**Eugene School District 4J
ROOSEVELT MIDDLE SCHOOL**
680 East 24th Avenue
Eugene, OR 97405
CIP No. 410.566.001

ADDENDUM NO. 6

This Addendum forms a part of the Contract Documents and modifies the original Bidding Documents dated February 18, 2015 and subsequent addenda as noted below. Acknowledge receipt of this Addendum in the space provided on the Bid Form. Failure to do so may subject the Bidder to disqualification.

WEST GRADING PLAN

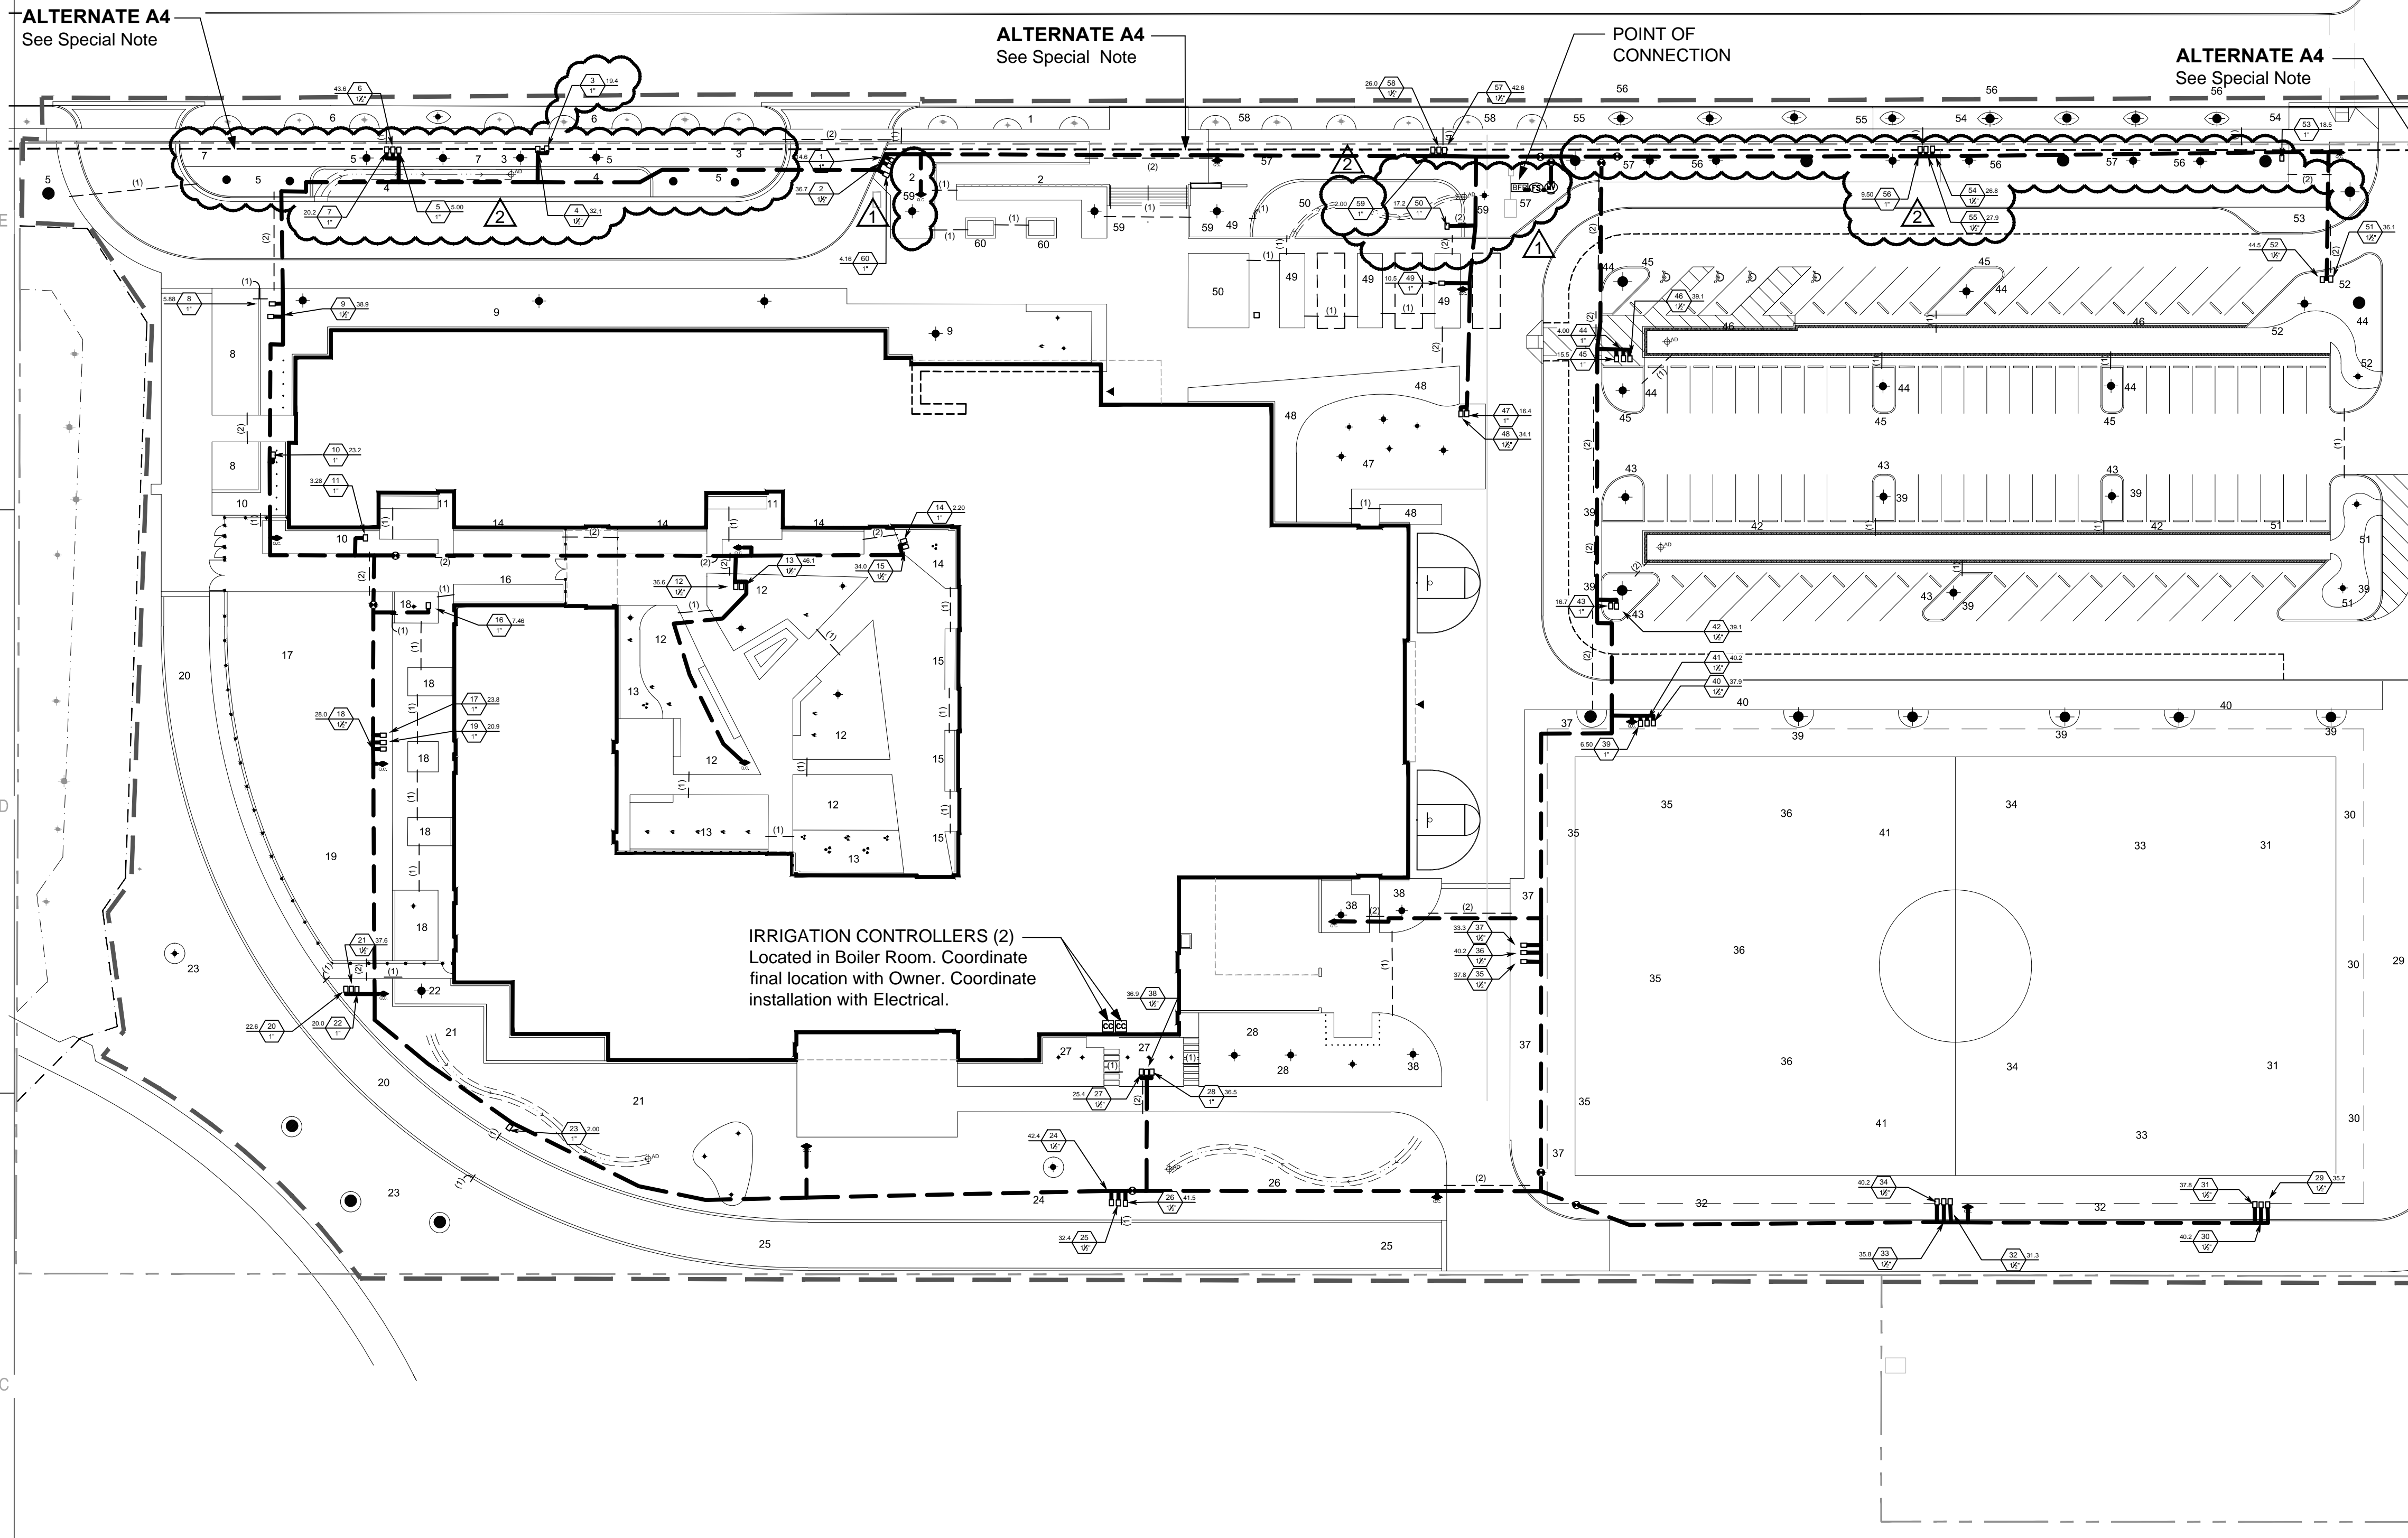
- A. Replace Sheet with revised Sheet L103.1: Change elevation of Area Drain Rim at grassy swale north of bus drop off area. Add elevations to concrete mowstrip at grassy swale north of bus drop off area.

L-104.1

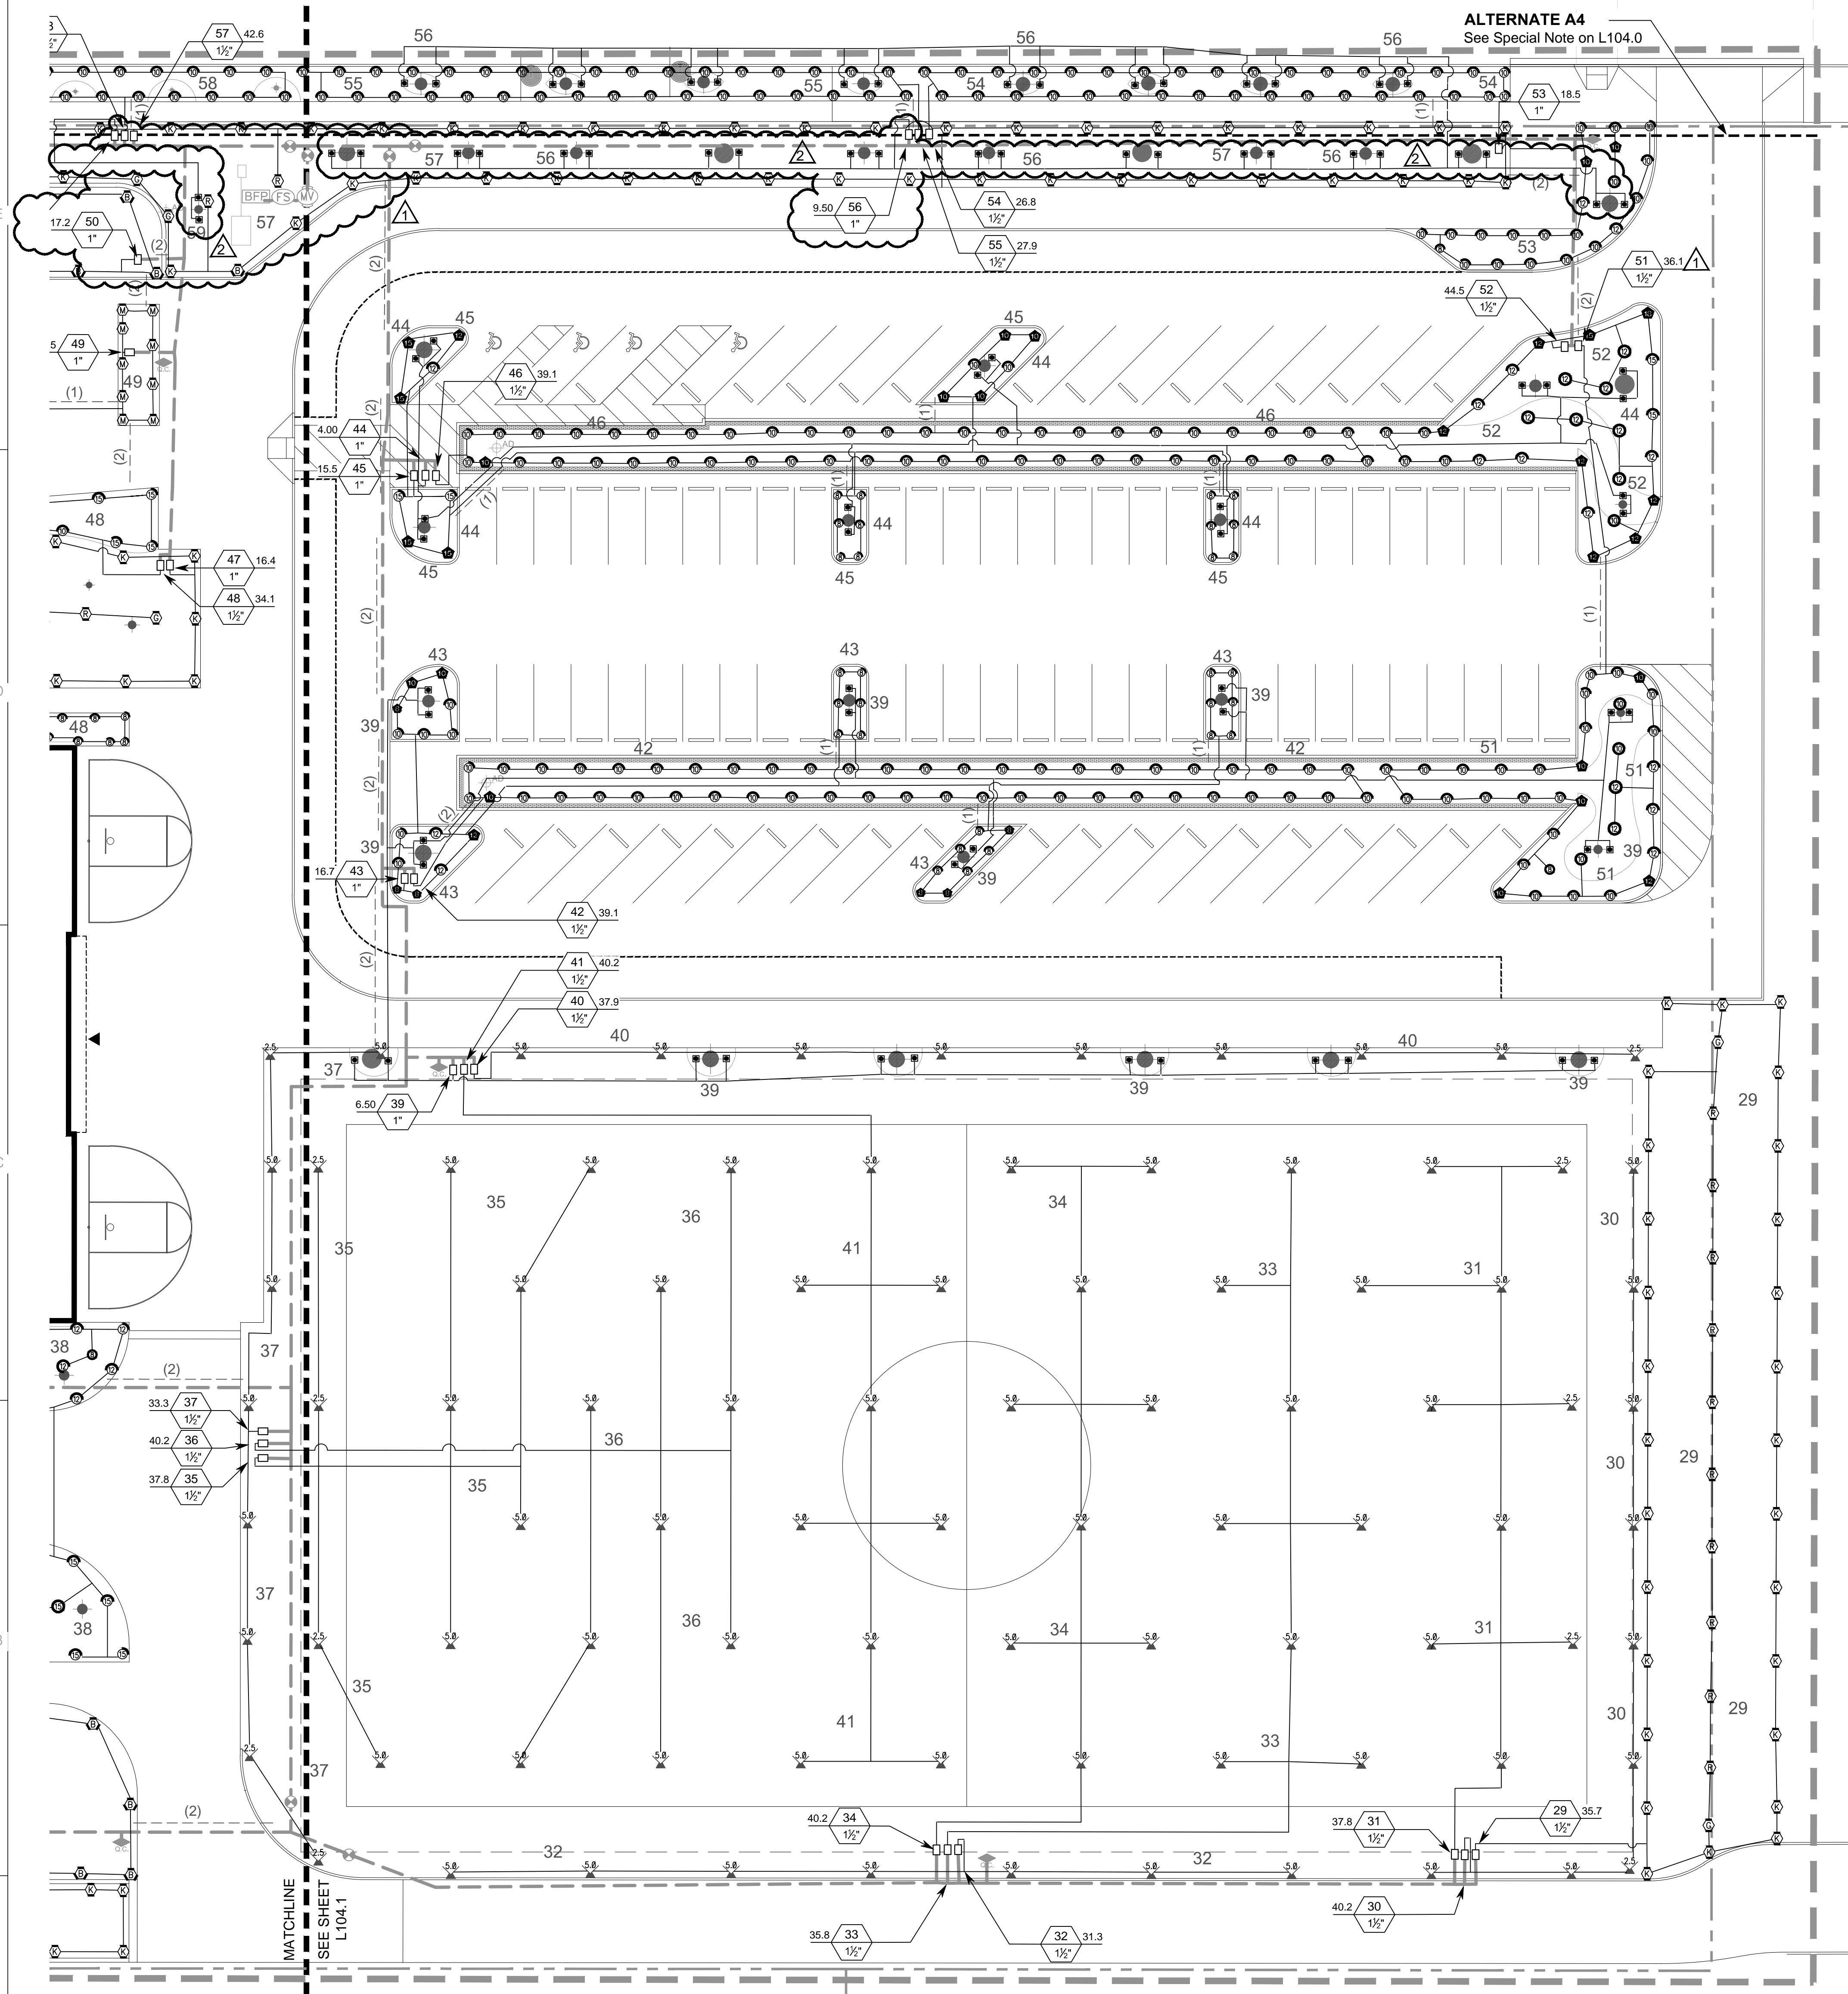
- A. Replace Sheet with revised Sheet L104.1: Adjust irrigation heads and change zone calculations at zones #3, #4 and #7. Update zone #15 zone calculations and upsize zone valve to a 1 ½" valve from a 1" valve. Update zone calculation for zone #59.

L-104.2

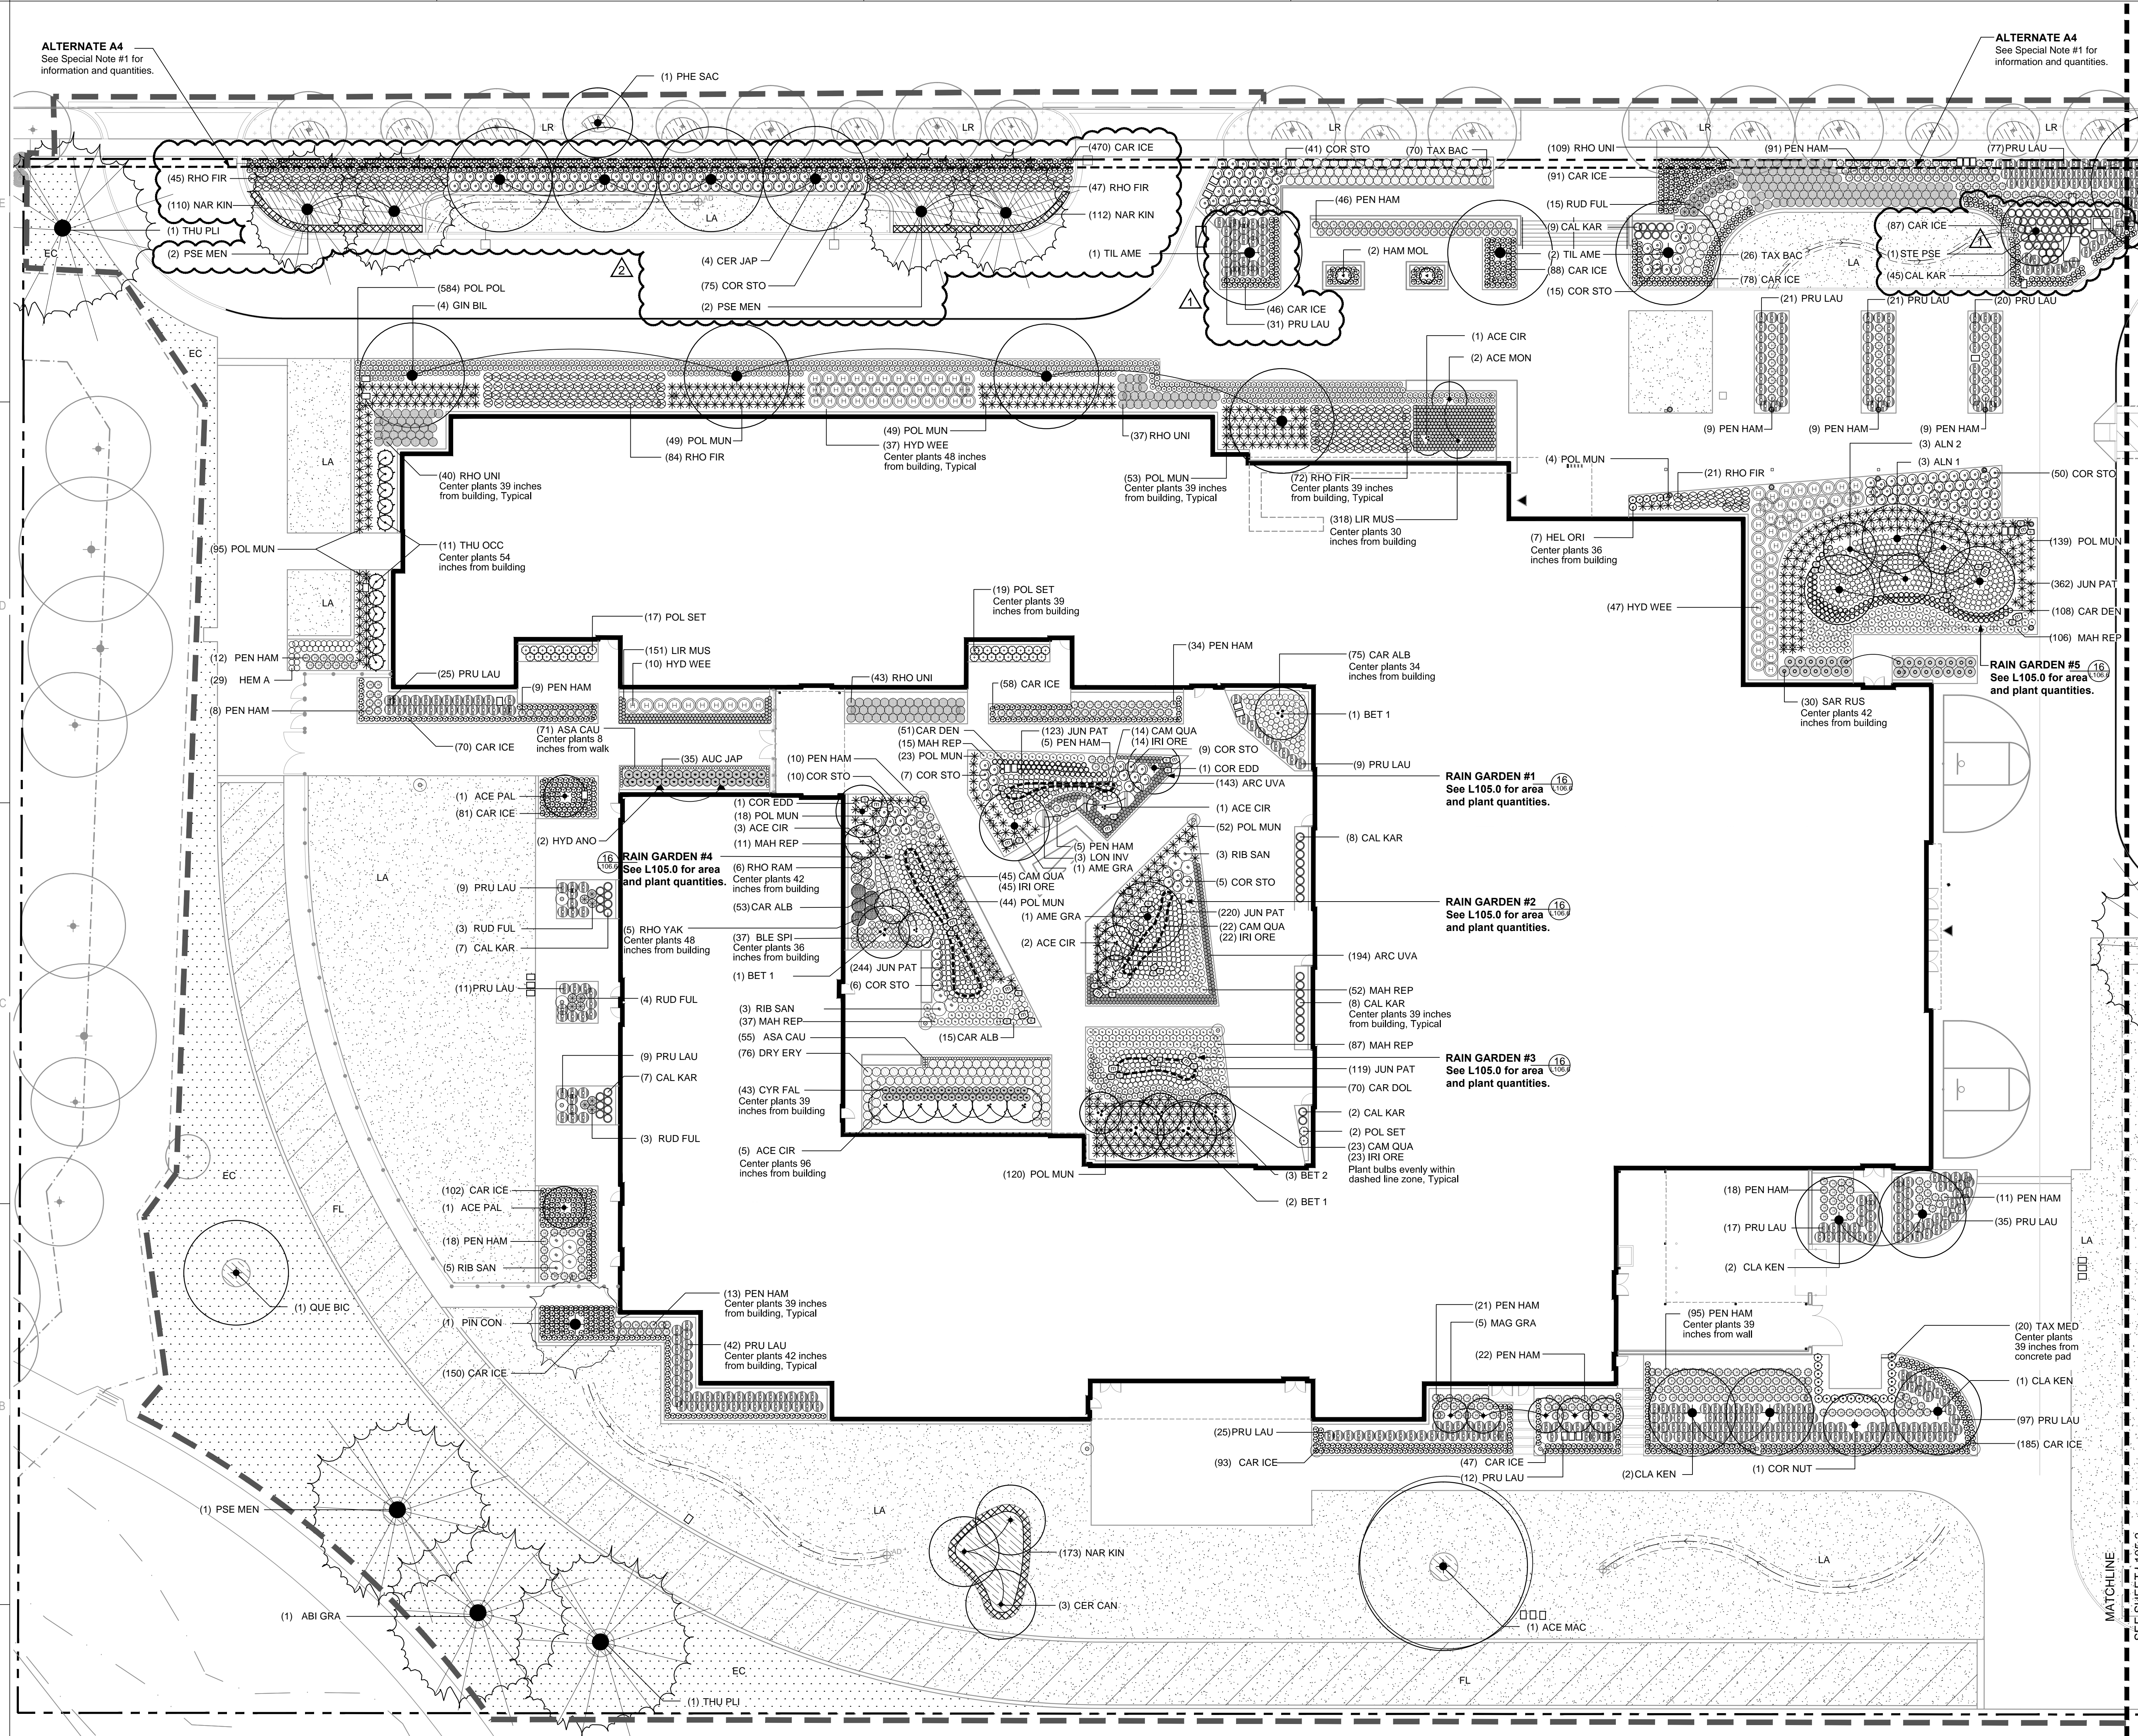
- A. Replace Sheet with revised Sheet L104.2: Add tree bubblers to zone #56 and update zone calculation.
